Before the FEDERAL COMMUNICATIONS COMMISSION Washington, D.C. 20554

In the Matter of)	
SES AMERICOM, INC.)	File No. SAT-MOD-
)	Call Sign S2135
Application for Modification of AMC-4)	
Fixed-Satellite Space Station License)

REQUEST OF SES AMERICOM, INC.

EIRP Pattern of AMC-4: Ku-band transponder 12, H-pol (down), original pointing

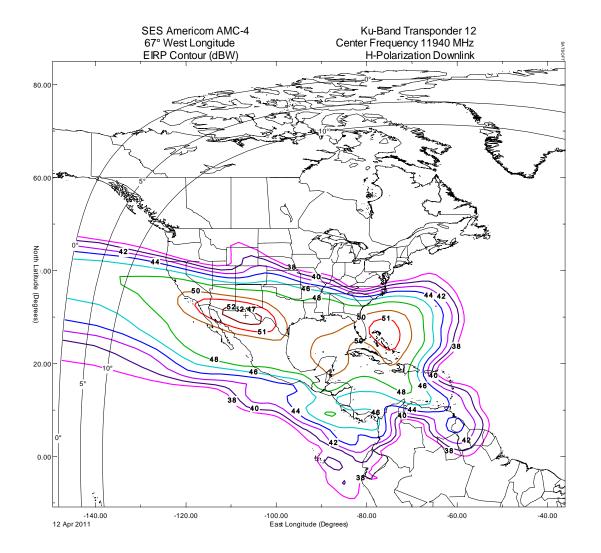
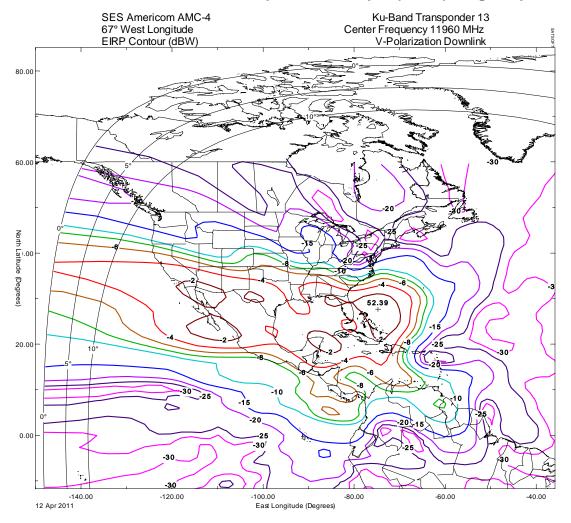
SES WORLD SKIES is attaching contour maps (Figures 1 to 8) showing the original and revised C-band and Ku-band EIRP patterns for typical horizontally and vertically polarized transponders of AMC-4 at 67° W.L.² The changes to the EIRP are so small that they produce no visible change from the original contours provided.

SES WORLD SKIES calculated the impact of the repointing on EIRP values at numerous receiver locations throughout CONUS, Canada, Mexico, Central America, and the Caribbean region. In the vast majority of these locations, the difference between the EIRP values with the original and revised pointing is very small, typically within ± 0.5 dB. The increase in Ku-band EIRP is greater than 2 dB at only two sites (2.2 and 2.3 dB). In the C-band, the change in EIRP values with the repointing is within ± 0.5 dB for all sites.

For example, in San Juan, Puerto Rico, the Ku-band EIRP for AMC-4 with the original spacecraft orientation was in the range of 36 to 40 dBW. With the repointing, the range is 38 to 41 dBW, an increase of between 1 and 2 dB. To determine the effect of a 2 dB
